Planned Development Rezoning Staff Report

Date: July 9, 2025
To: Douglas County Planning Commission
From: Trevor Bedford, AICP, Senior Planner *TB*
Curtis J. Weitkunat, AICP, Planning Manager *CW*
Steven E. Koster, AICP, Assistant Director of Planning Services *SK*
Subject: **Ramblewood Planned Development - Rezoning**
Project File: **ZR2024-031**

The applicant requests a rezoning of approximately 176.79 acres from Agricultural One (A-1) and Rural Residential (RR) to Planned Development (PD). The site is located on the south side of Hilltop Road, across from its intersection with Merryvale Trail.

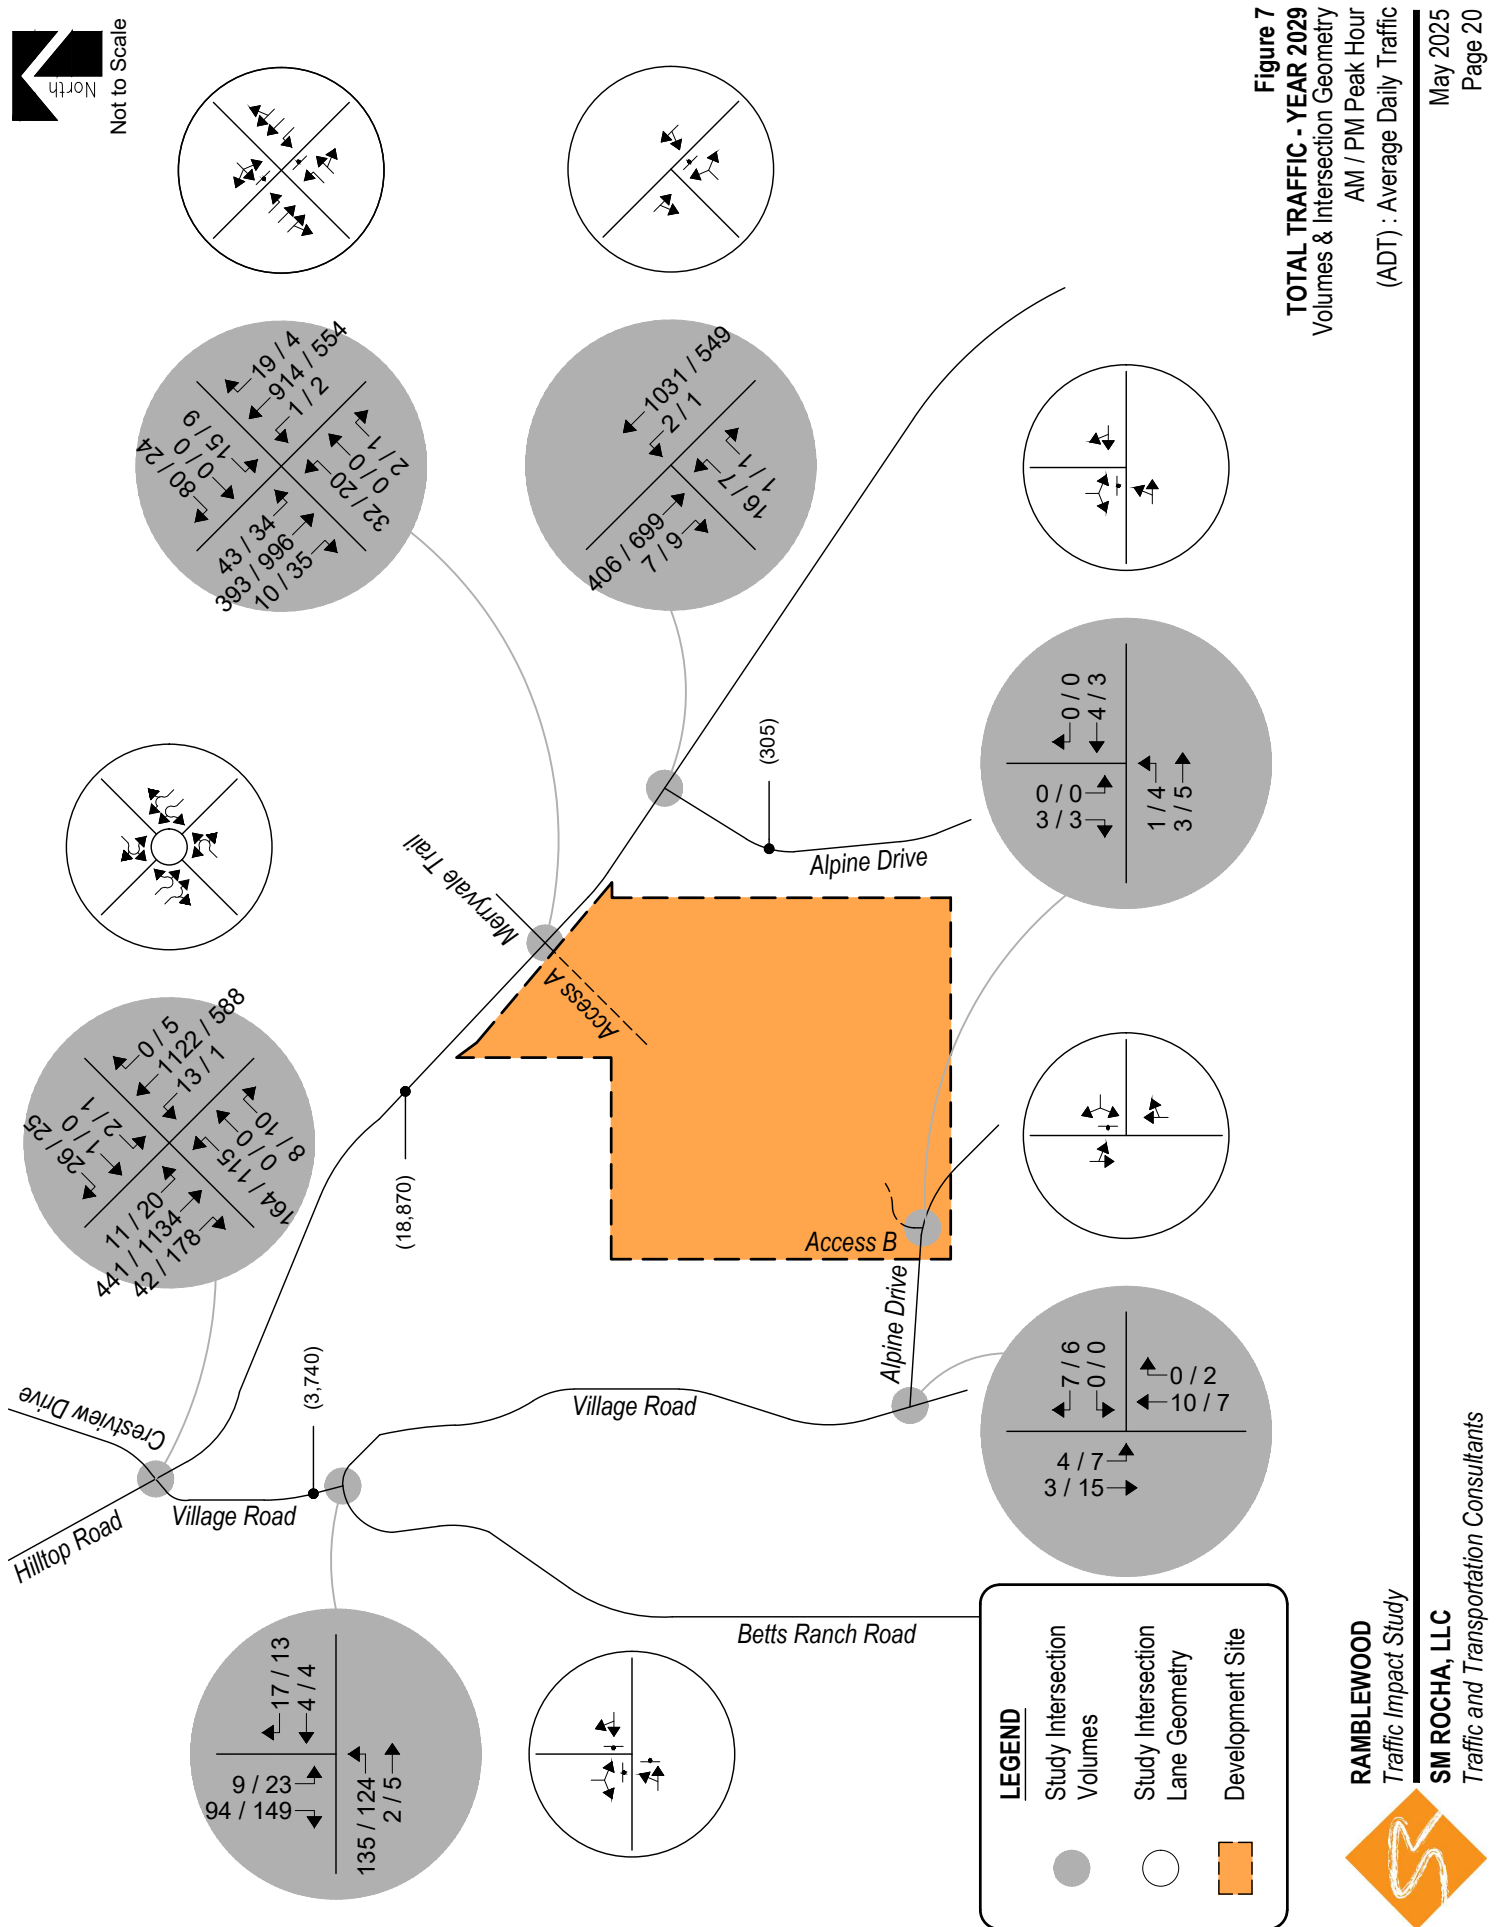
- Future year intersection geometry: per Figure 7 this analysis assumes that the northwest bound left turns from Hilltop Rd will be made from a shared through/left turn lane. This is not typical for higher classification – 4-lane roadways. This study should analyze this approach assuming a dedicated left turn lane for all the future scenarios.

- Hilltop Rd at Access A/Merryvale Trail
 - Future year intersection geometry: per Figure 7 this analysis assumes that the northwest bound left turns from Hilltop Rd will be made from a shared through/left turn lane. This is not typical for higher classification – 4-lane roadways. This study should analyze this approach assuming a dedicated left turn lane for all the future scenarios.
Response: Noted. Auxiliary lane analysis added.
 - For the northeast bound approach to Hilltop Rd (Access A) it is assumed in the analysis that left, through, and right turning movements are made from a single lane approach. Although it will likely not make a significant change to the LOS for this approach, this study should assume that there would be a dedicated left turn lane and a shared through/right turn lane.
